FINAL FOR REVIEW  
JAN. 20, 2011

RIDGEWALK PARKWAY OVER I-575  
CHEROKEE COUNTY

REINFORCED EARTH RETAINING WALL

WALL 2 ELEVATION

WALL 2 ELEVATION - FRONT FACE

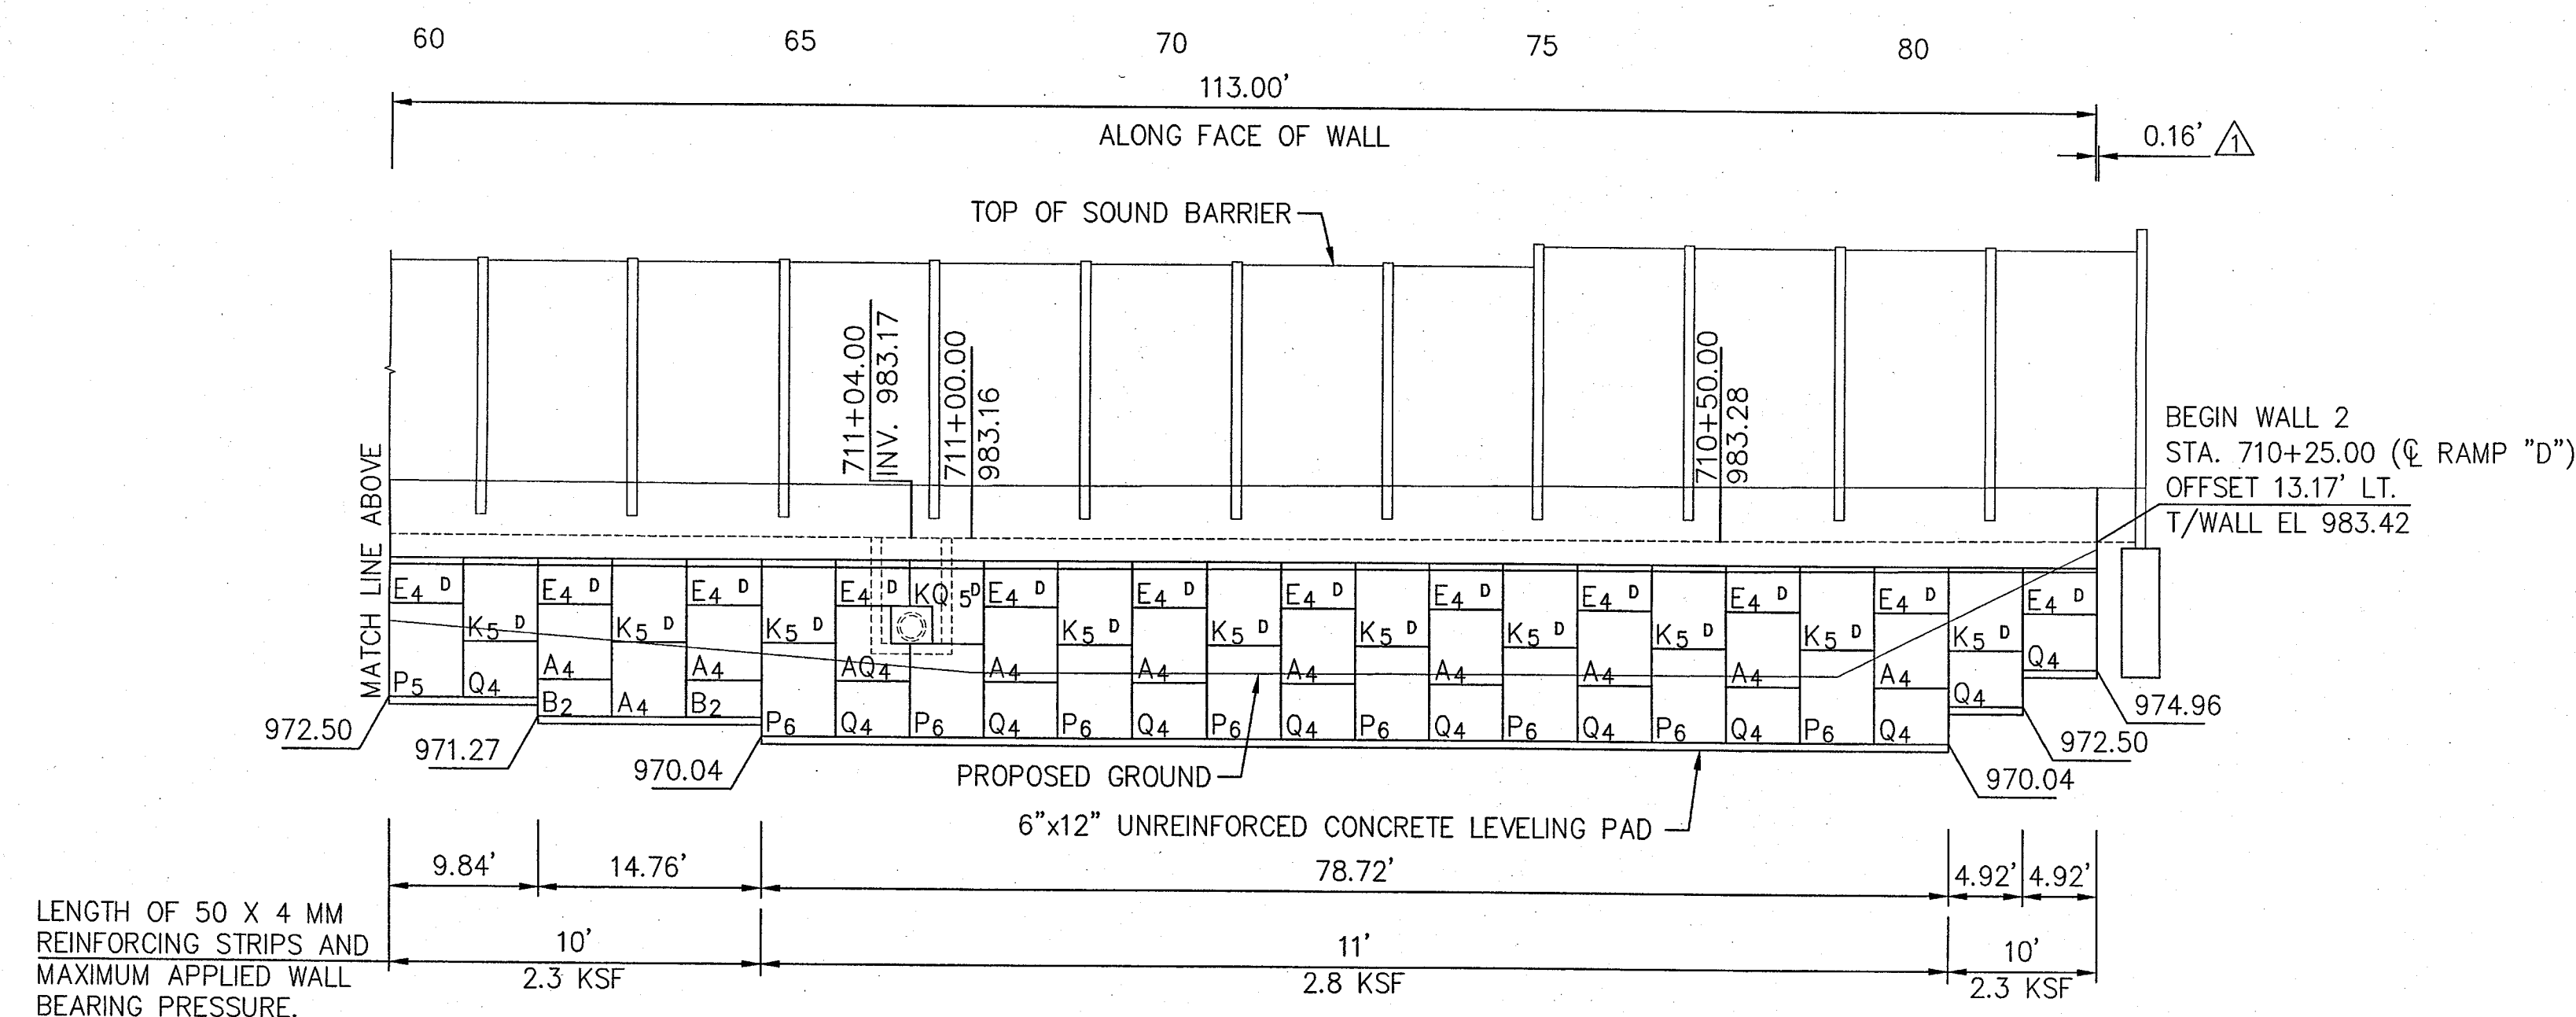
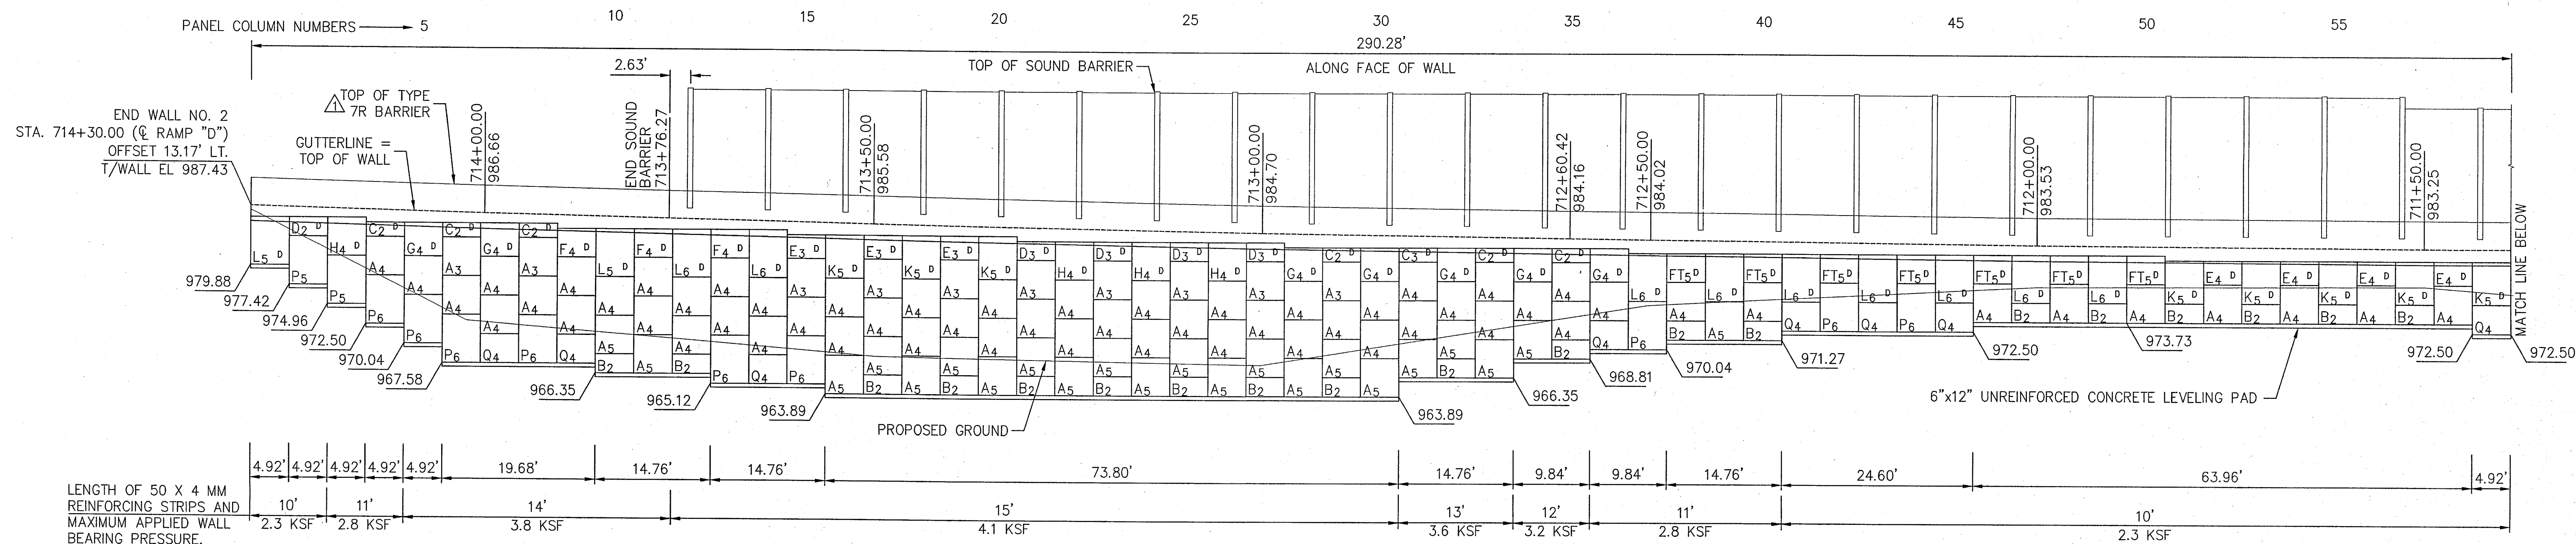
Approved in general. Details not checked. This approval shall not relieve the Contractor of any responsibility for conformity with the contract Plans and Specifications.
